# AMENDMENTS TO DA APPROVED STUDIO

## 17 Old Sydney Road, Seaforth

**CALCULATIONS  
REMAIN AS PER  
APPROVED DA  
NO: DA2021/1835**

## FLOOR PLAN

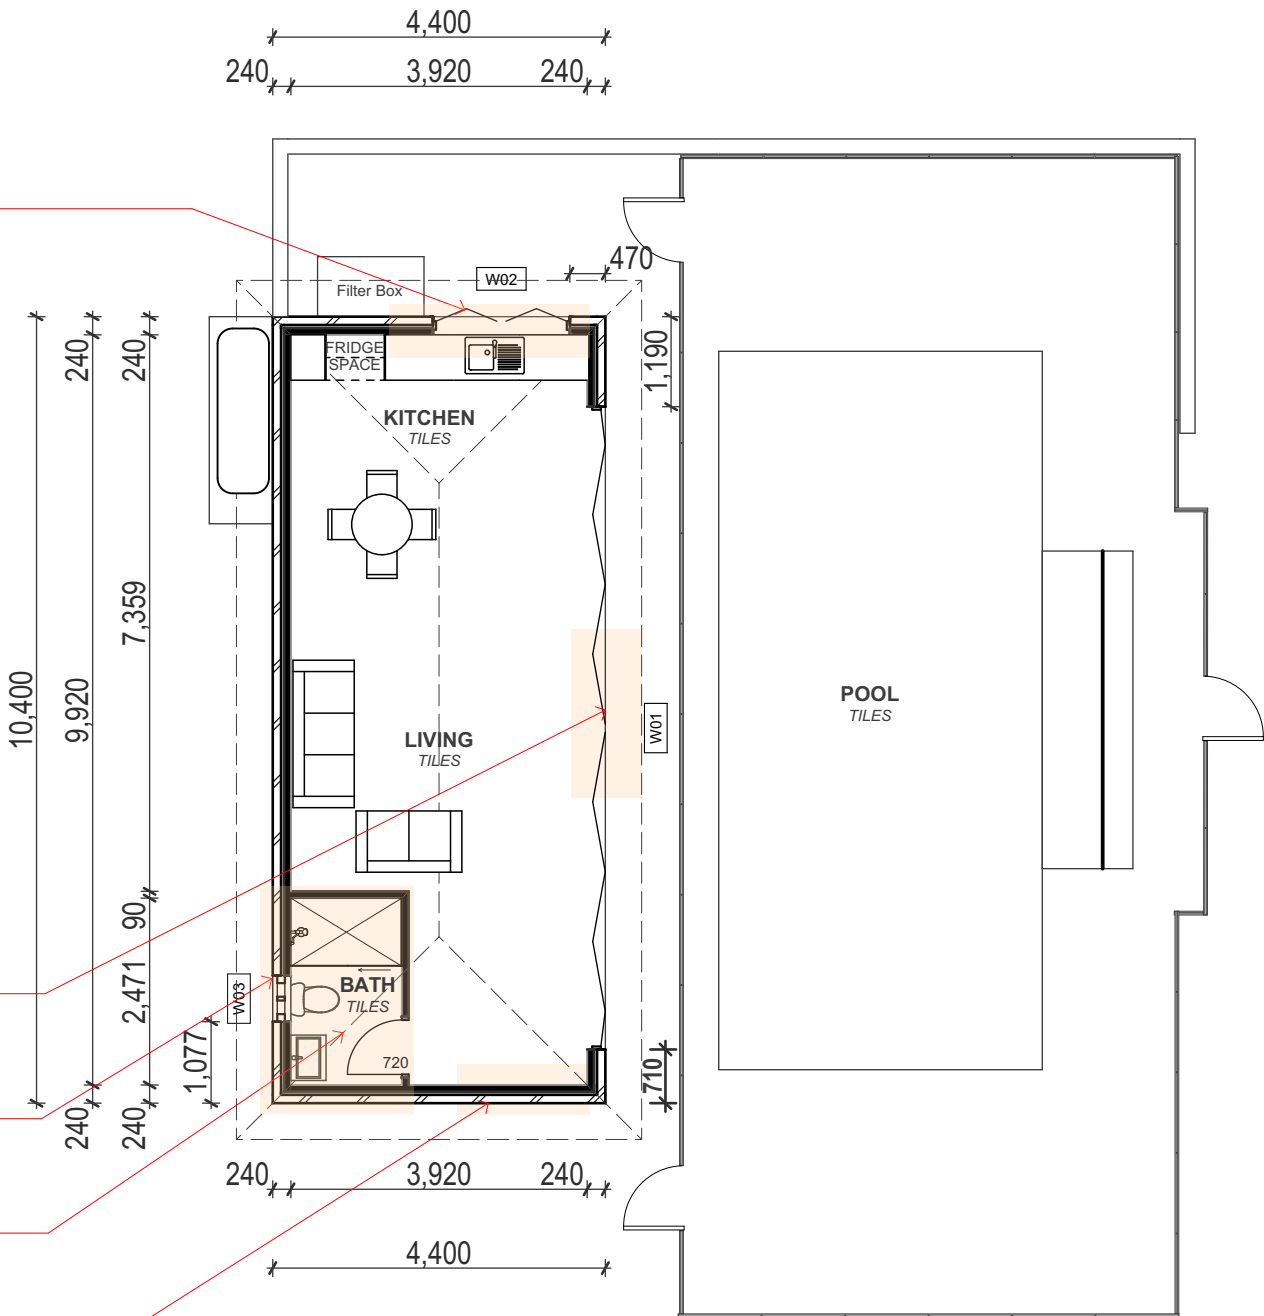
**BIFOLD WINDOW MOVED TOWARDS FB**  
**WIDTH CHANGED FROM**  
**1370 mm TO 1810 mm (H 1029)**

**BI-FOLDING DOORS WILL HAVE**  
**ITS TWO CENTER PANELS HINGED**

**BATHROOM WINDOW MOVED**  
**TO THE MIDDLE**

**BATHROOM LAYOUT**  
**CHANGED**

**DOOR REMOVED**
